August 3, 2026

TO : All Bidders
FROM : Susanto Agustiadi
PROJECT : El Roble IS PE Building Modernization
250176
SUBJECT : Addendum 2
DSA : A#03-125612

PE BUILDING
MODERNIZATION AT
EL ROBLE IS

AD101

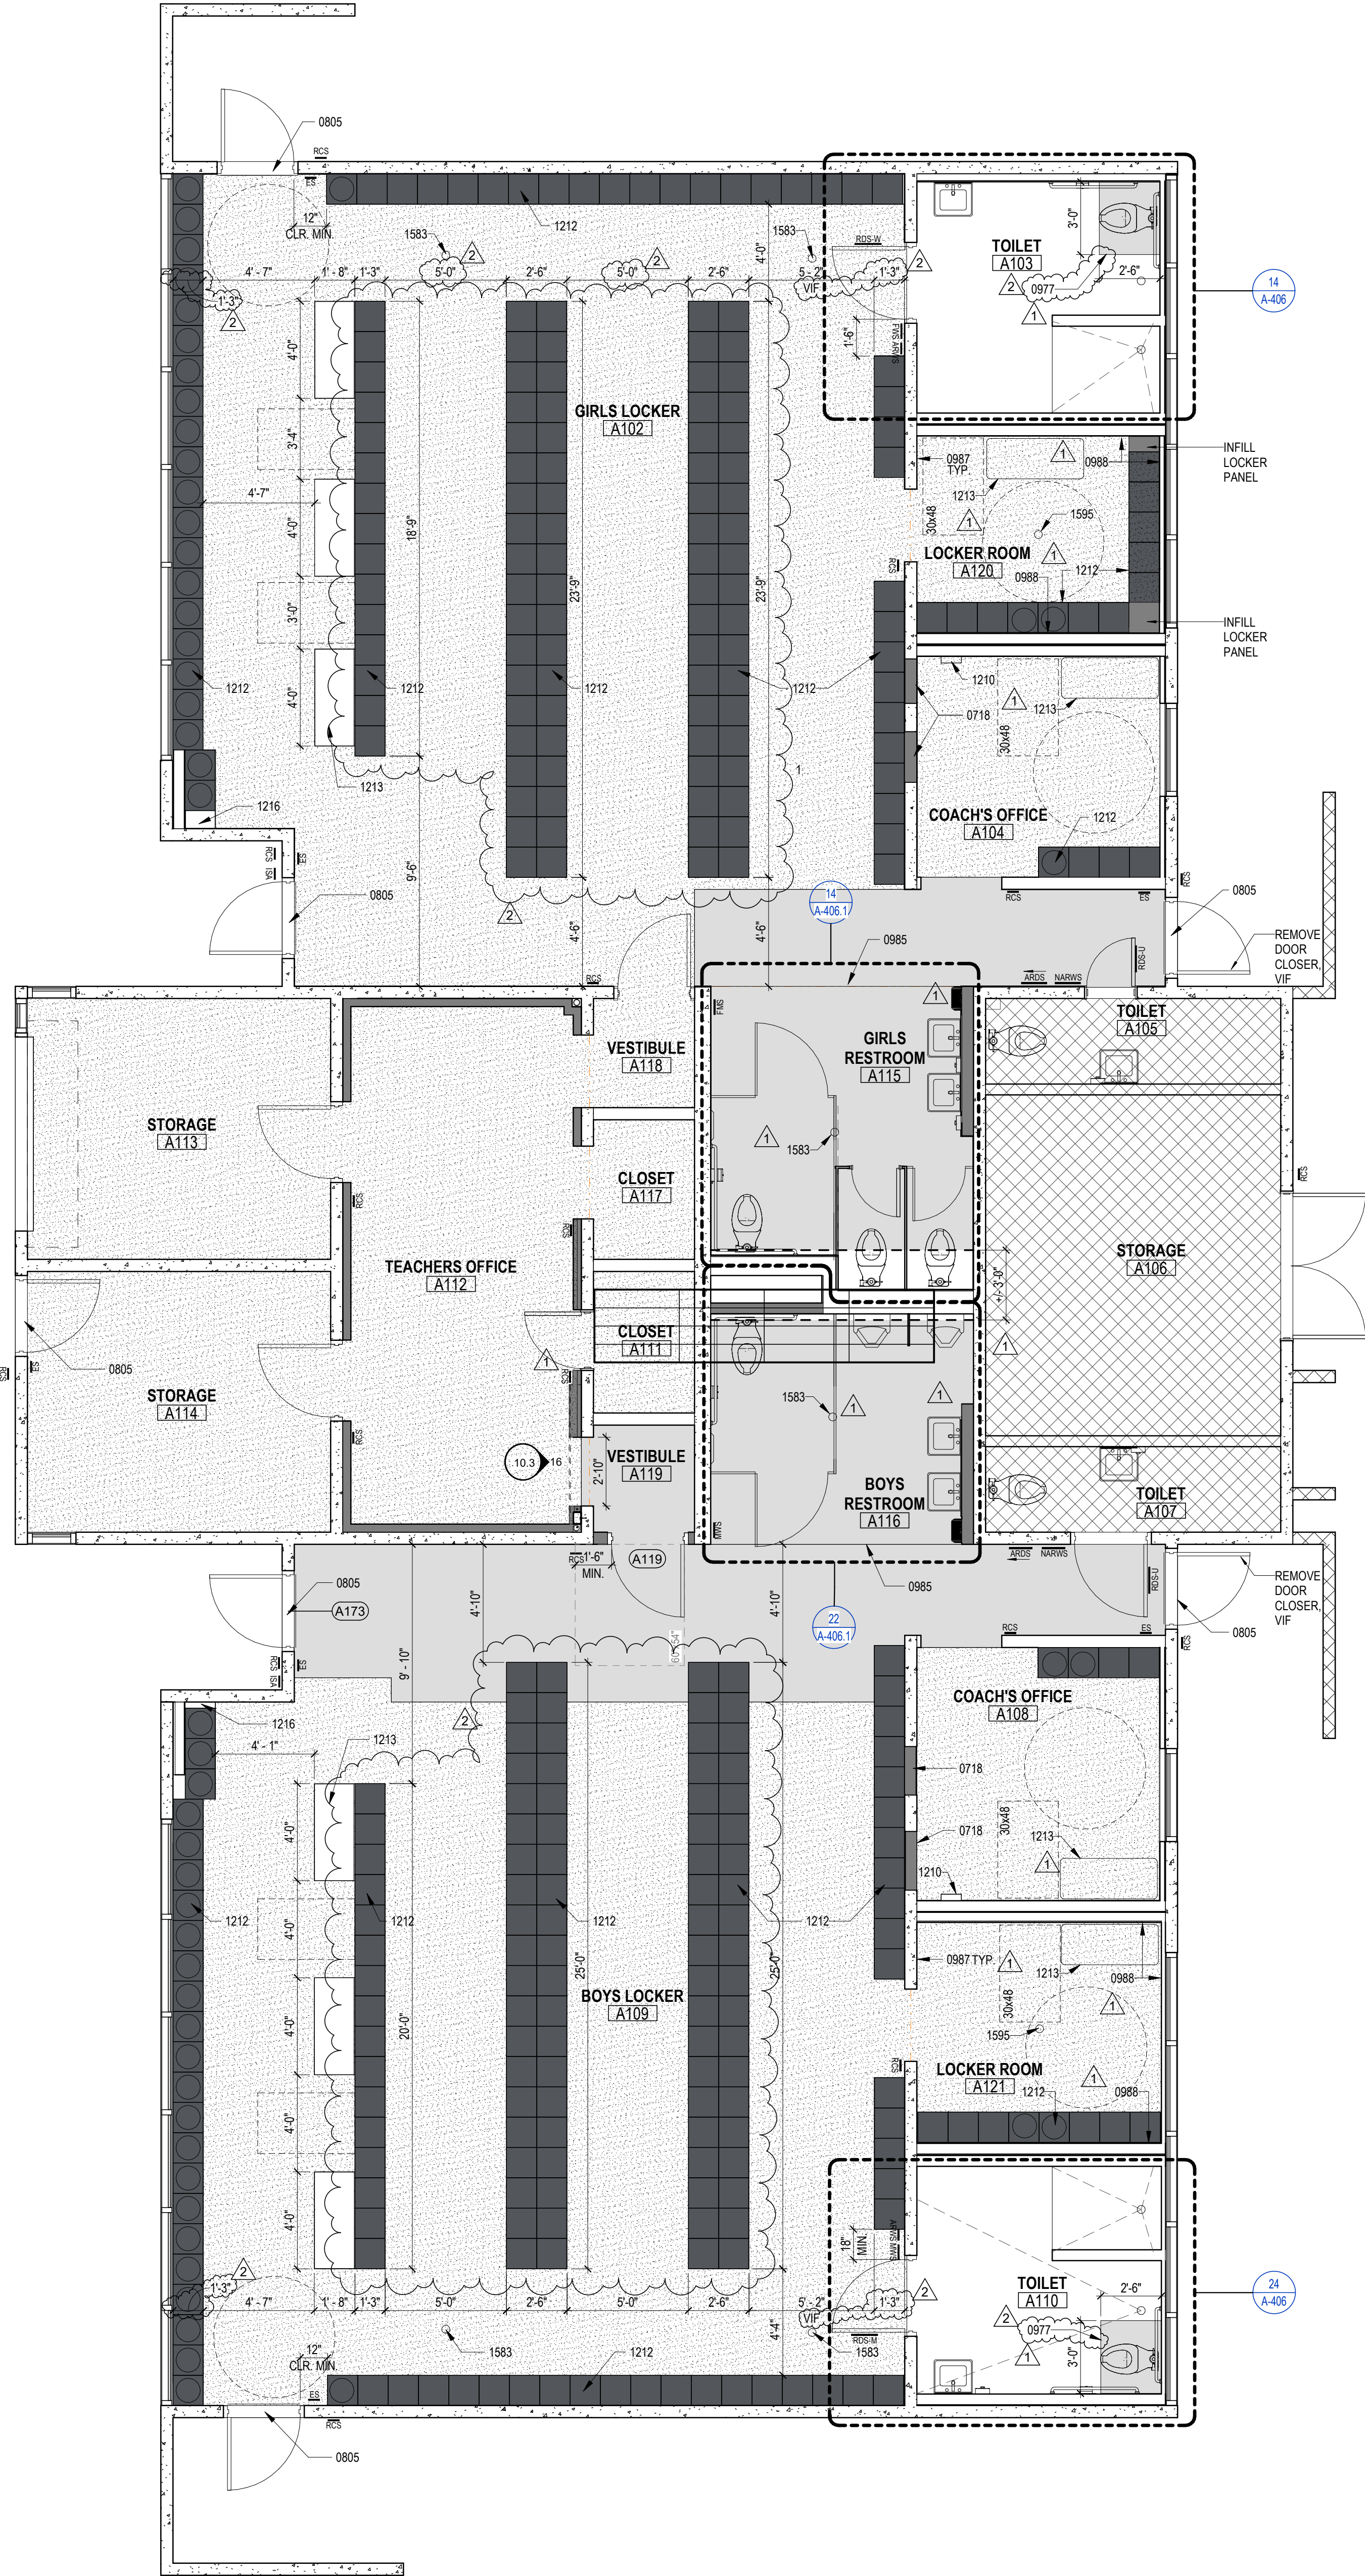
6. Q: Reference note 1212 on A-101 says "Student Metal Lockers on concrete base (OFCl), Ref Detail 7/10.3 Typ. Please clarify
- A: Only Student Metal Lockers including filler panels are Owner Furnish Contractor Install (OFCl), concrete curb is part of this contract. Locker's benches are Contractor furnish Contractor Install (CFCl)

10.3

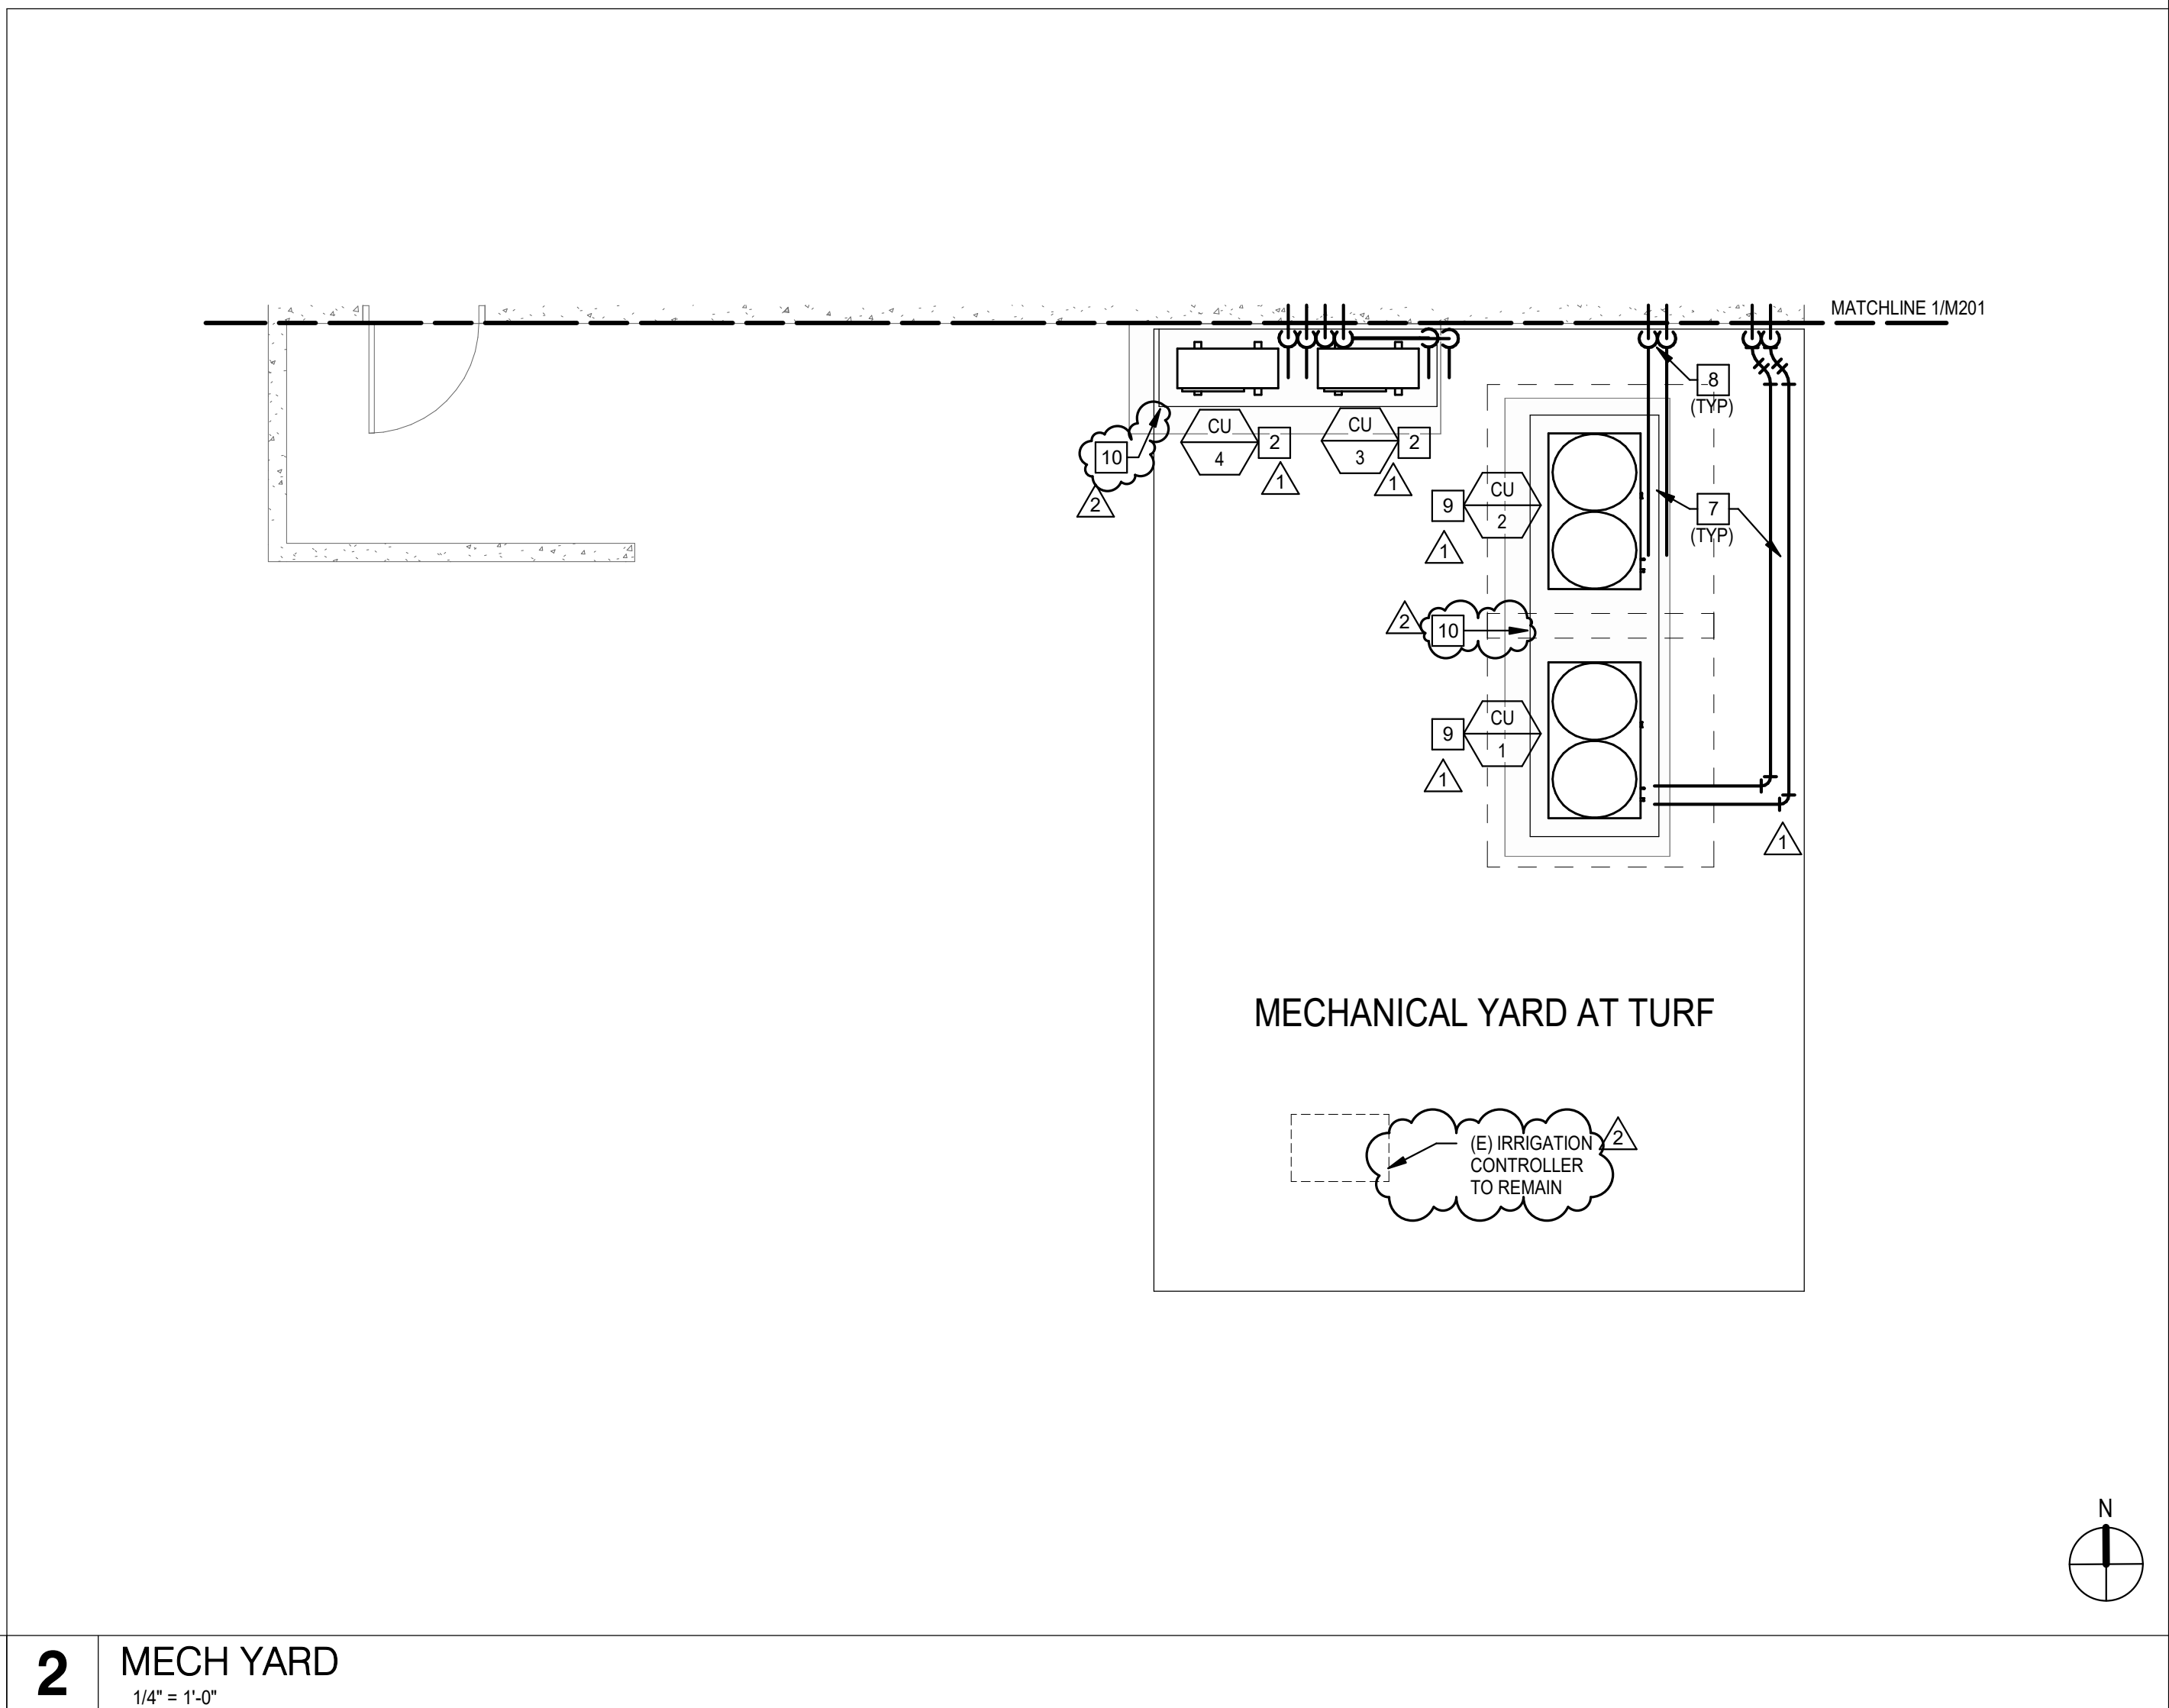
- A. Omit items 2.5 A, B and C and replace them with the following:
 - A. 24"D x 48" L Hardwood Maple Bench with 20" high back rest.
 - B. Bench Support: Powder coated steel, color to be selected from standard colors
 - C. Height of Bench: Per drawing
